Fiber Cement with EasyTrim - Trim Summary

Project Name: John Grace Arms
Location: 21030 Indian St.
Project No: 99025
Project Address: Southfield, MI 48033
Date: November 06, 2025

Fiber Cement with EasyTrim - Bill Of Quantities

- Drawing reference: **"BULLETIN #1" dated 02.19.2025**
- Estimator assumed that whole wall will be replaced with Fiber Cement Panel, hence, Face Brick and Precast Stone are to be supplied with 5/16" EasyTrim. See page 11.**

CLIENT TO VERIFY | PRECAST STONE DETAILS

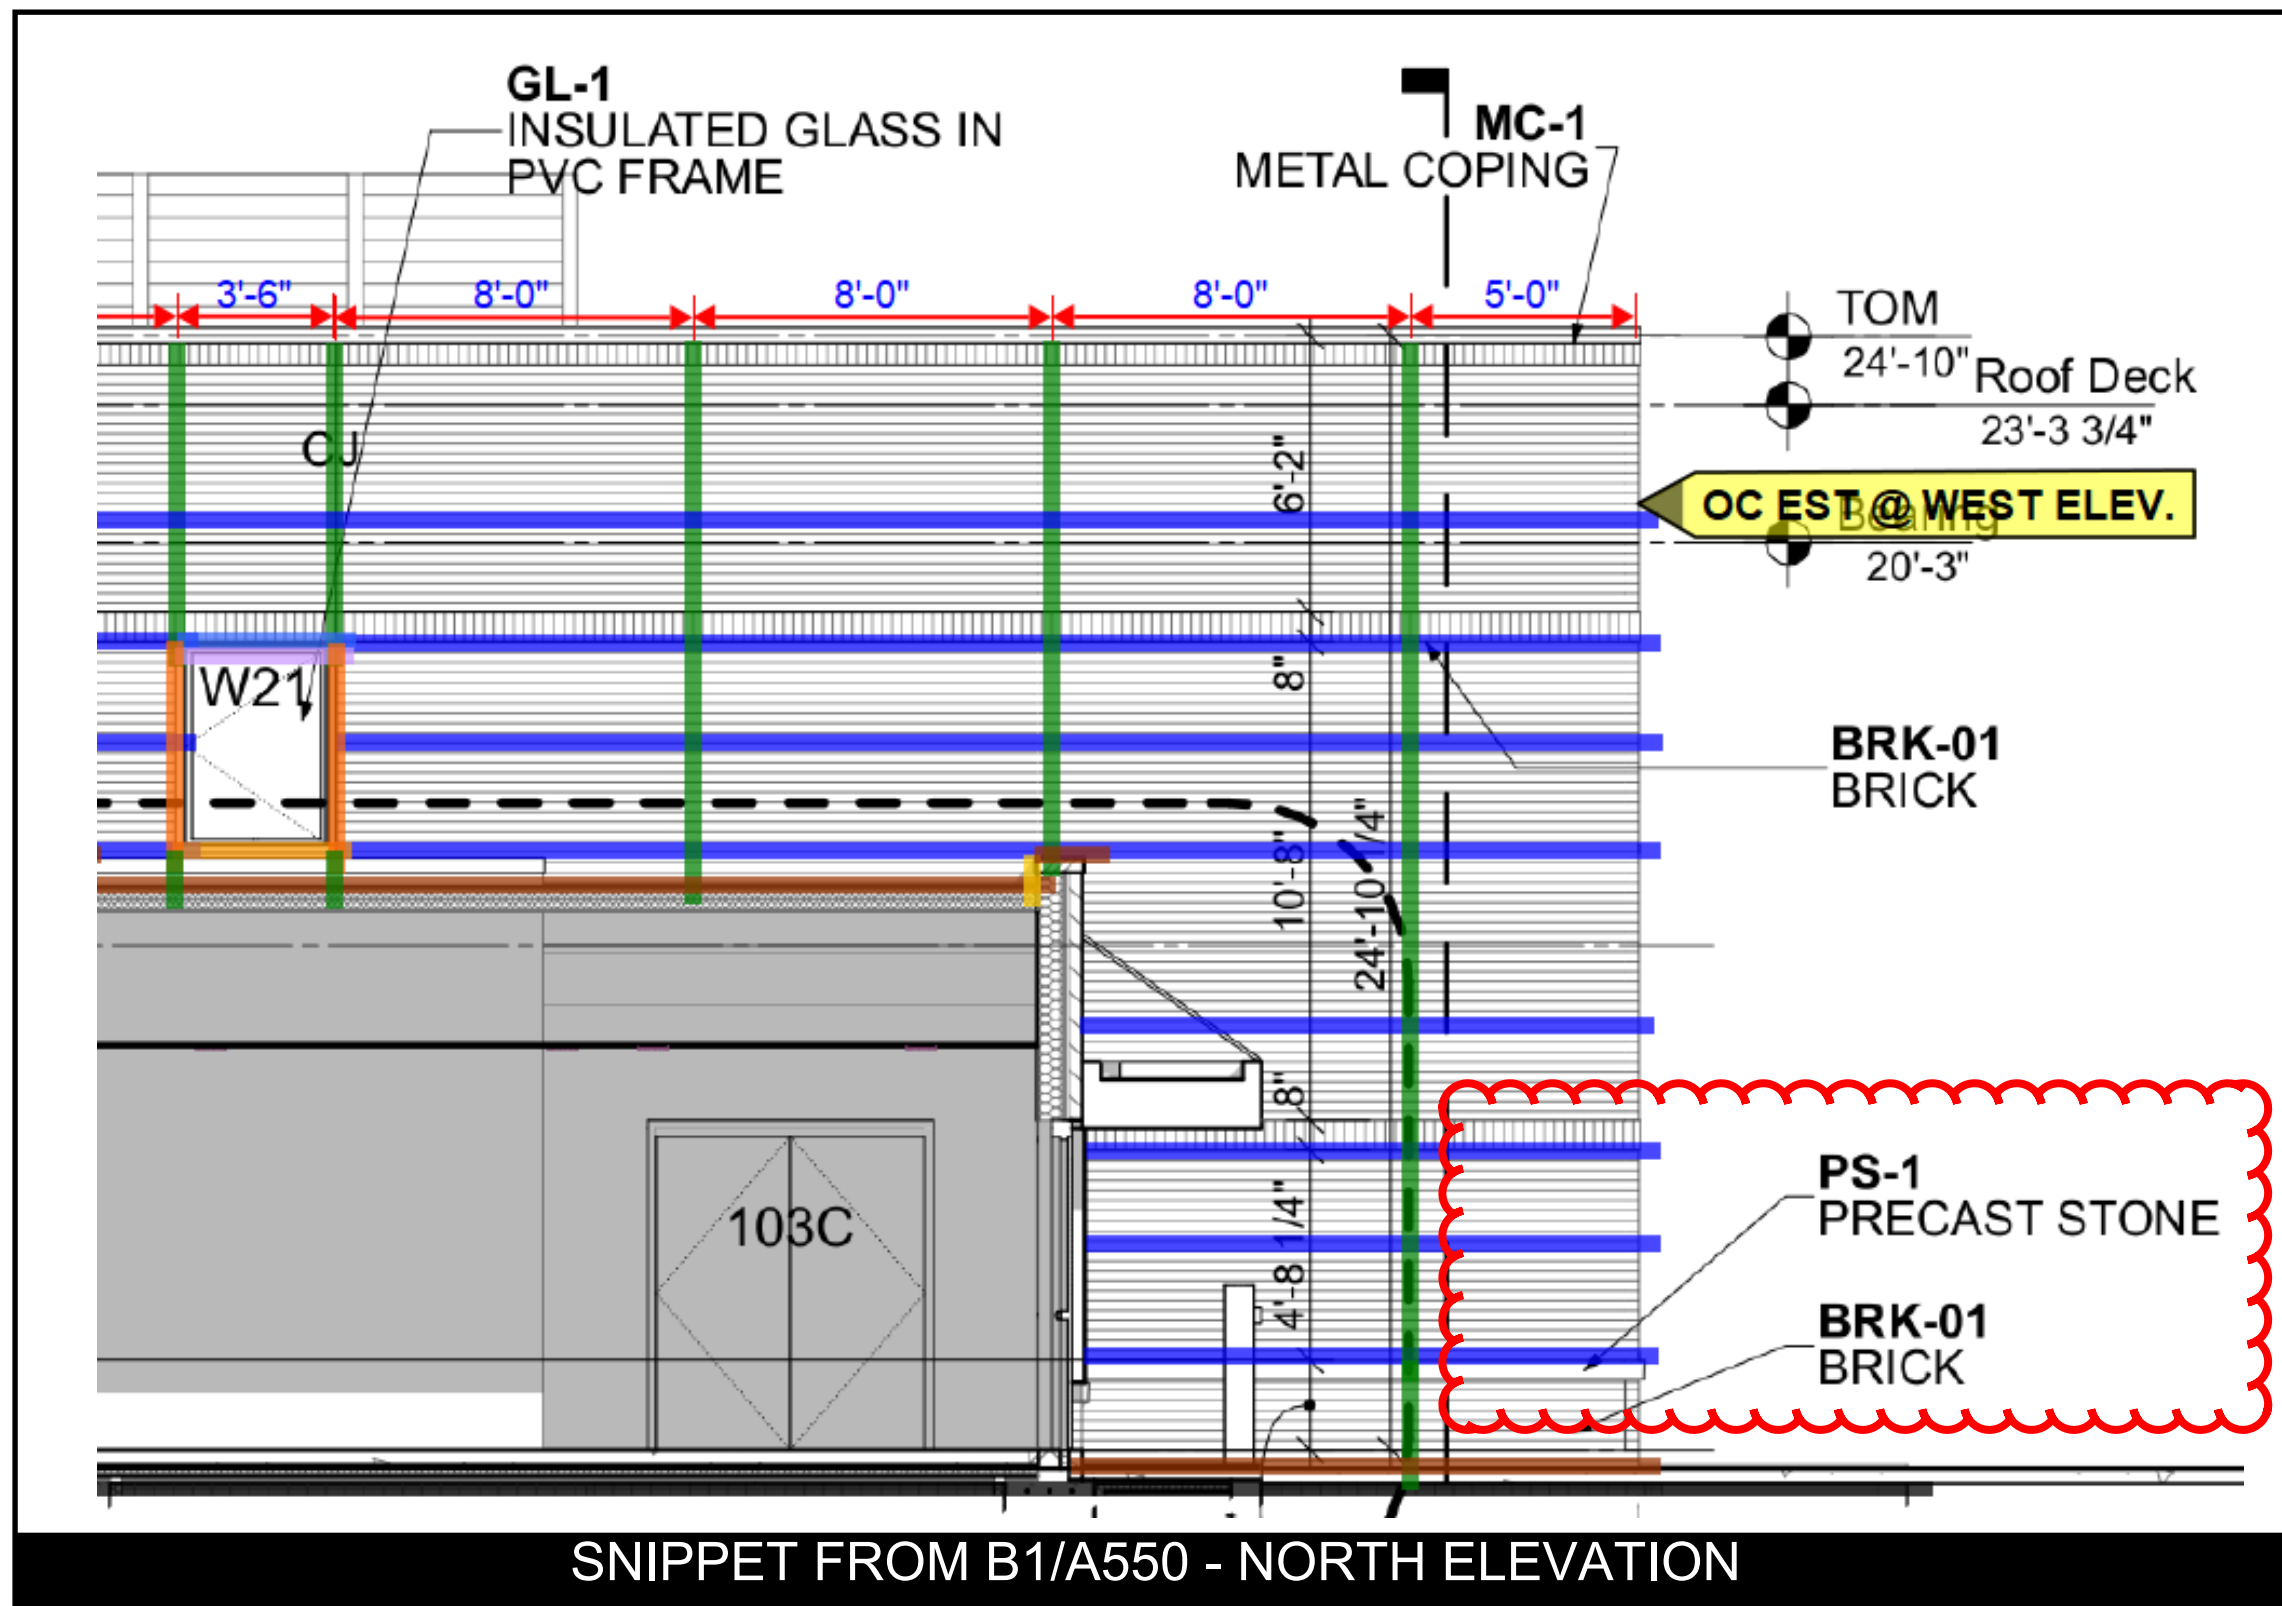
CLIENT TO VERIFY, PRIOR TO ORDERING:

Estimator assumed that whole wall will be replaced with Fiber Cement Panel, hence, Face Brick and Precast Stone are to be supplied with 5/16" EasyTrim. See detailed takeoff on pages 22-25.

CLIENT TO VERIFY | NARROW-WIDTH AREAS

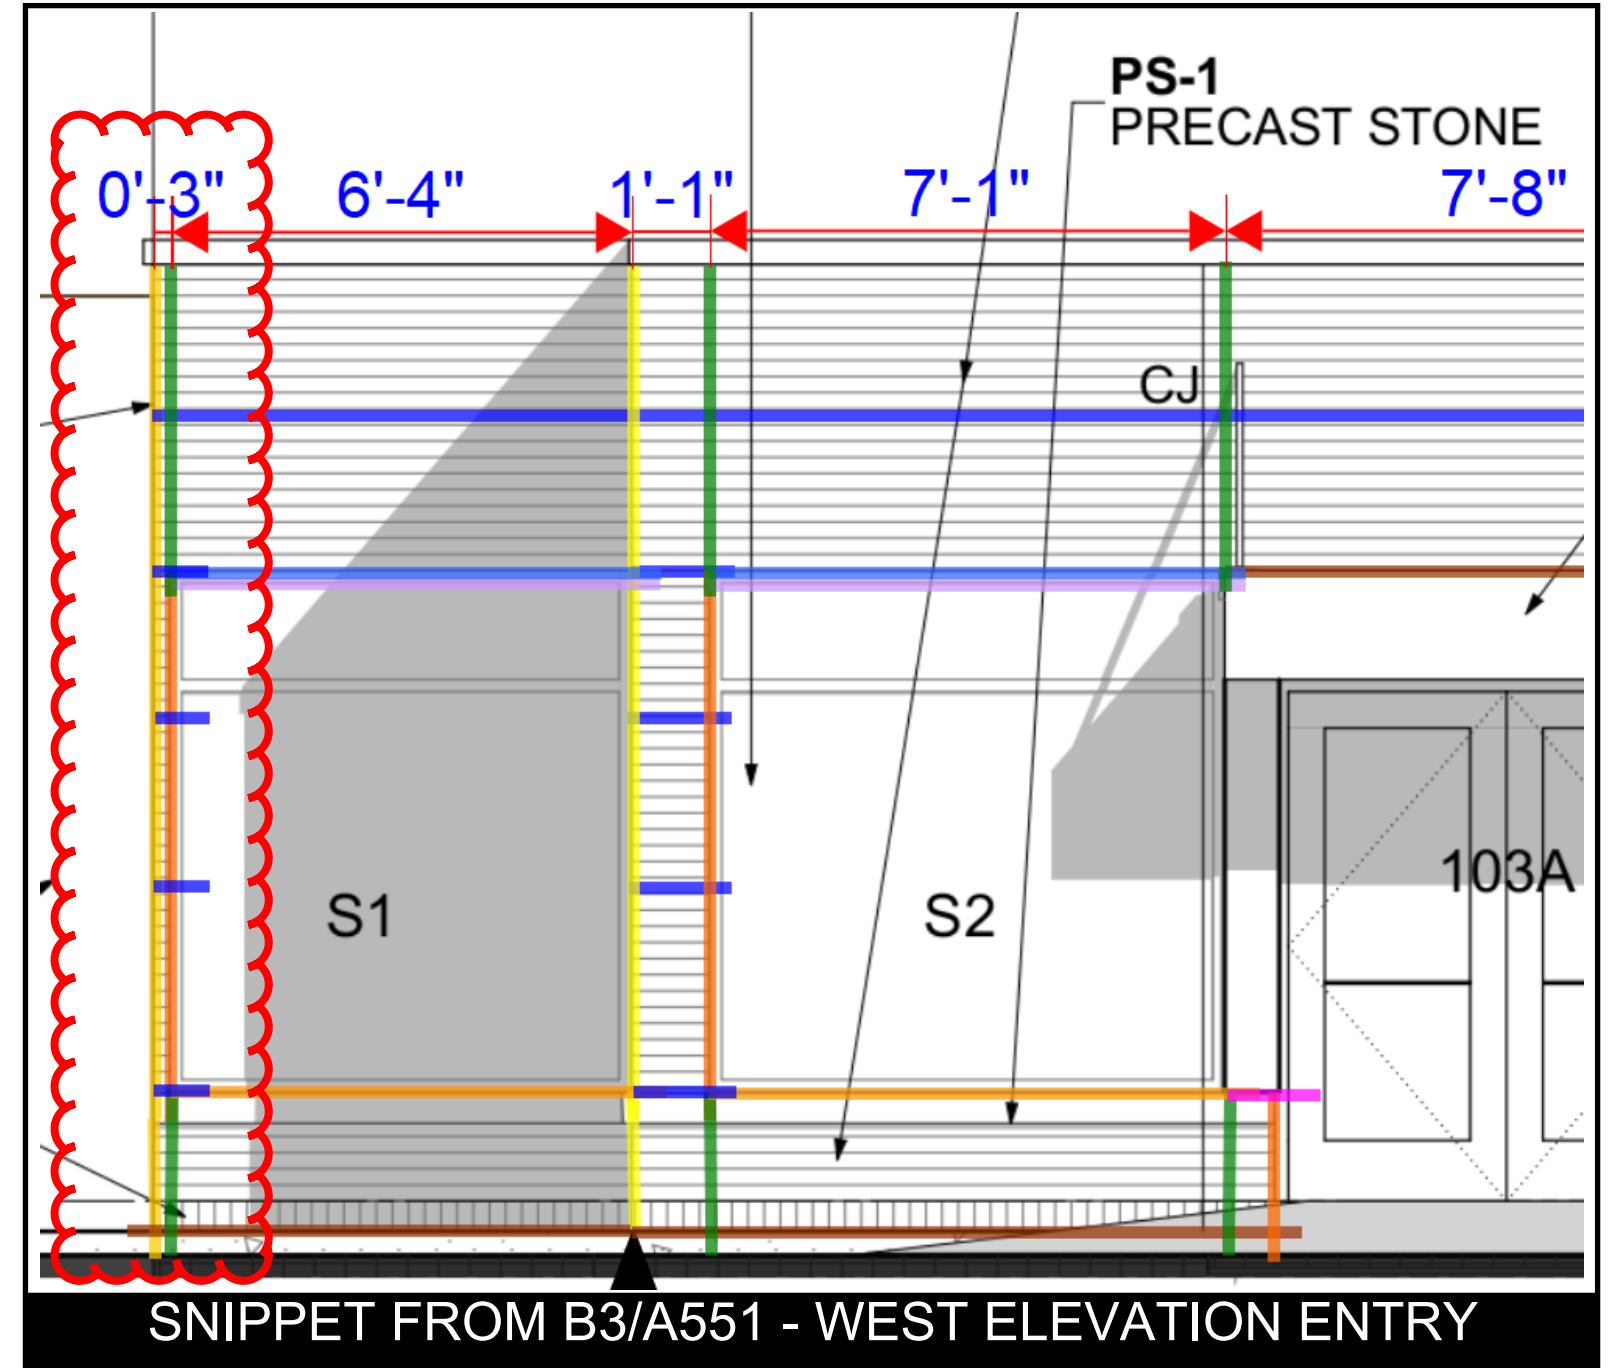
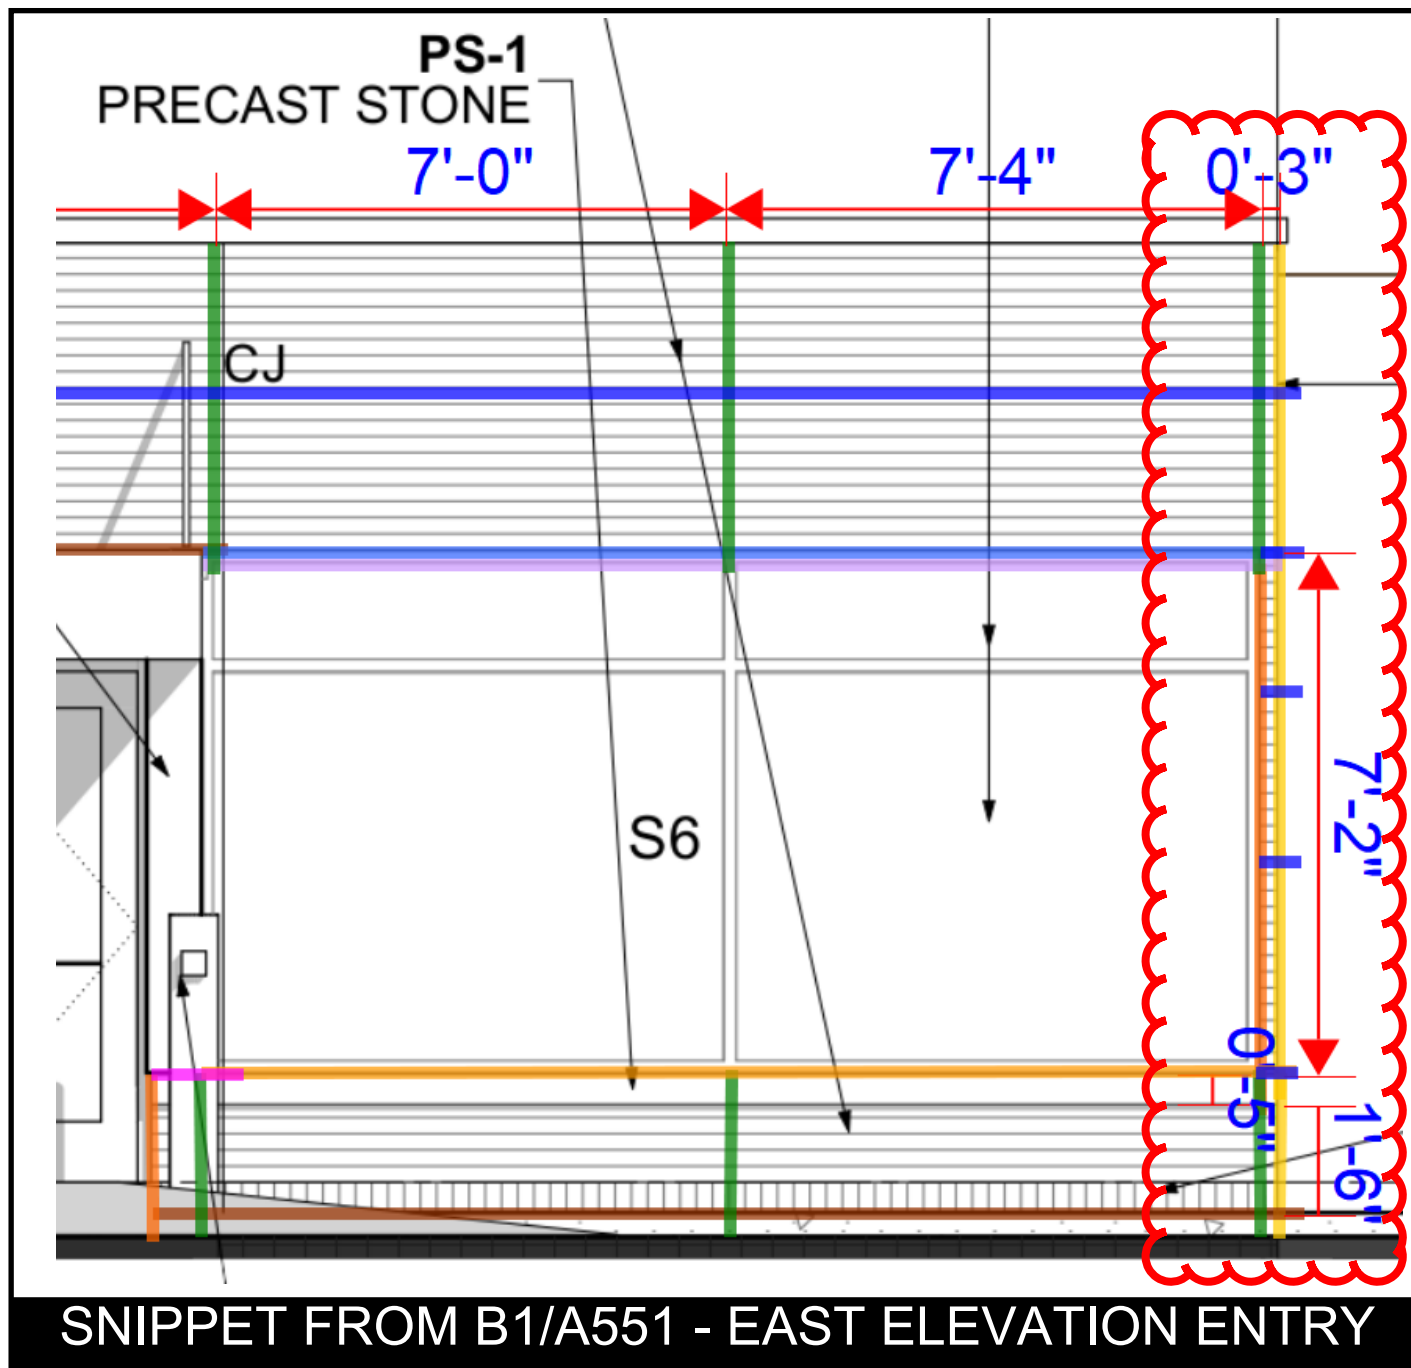
CLIENT TO VERIFY, PRIOR TO ORDERING:

EasyTrim estimated on narrow-width areas. Client to verify actual site dimensions to meet EasyTrim minimum dimension requirement prior to ordering. Otherwise, Client to provide Bent Metal Flashing **BY OTHERS**.

DESCRIPTION MINIMUM DIMENSION OF JAMB TO OUTSIDE CORNER USING EZ08 & EZ01			
 EasyTrim® Reveals	SCALE	NTS	DRAWING NUMBER
	DATE	22AUG23	EZM-76
	DRWN BY	AJ

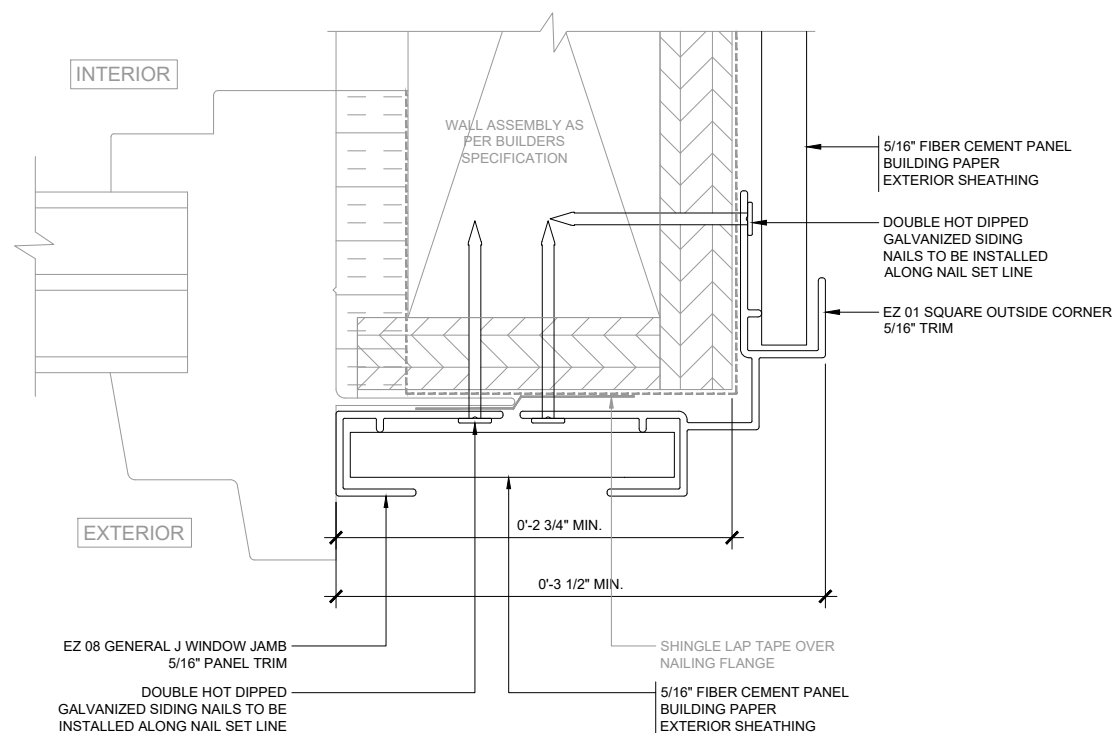
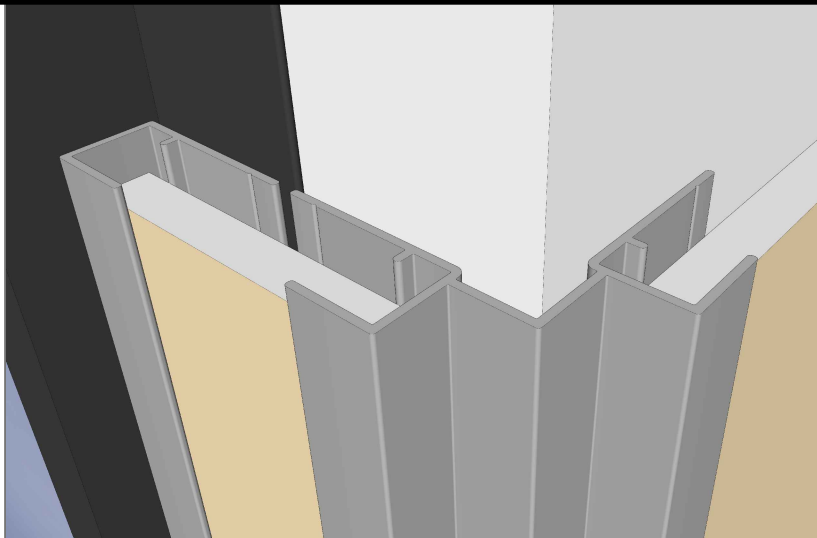
NOTE: Minimum dimension required for EasyTrim system to work using EZ 08 & EZ 01 is **3-1/2 IN.**
See page 12 for minimum dimension reference
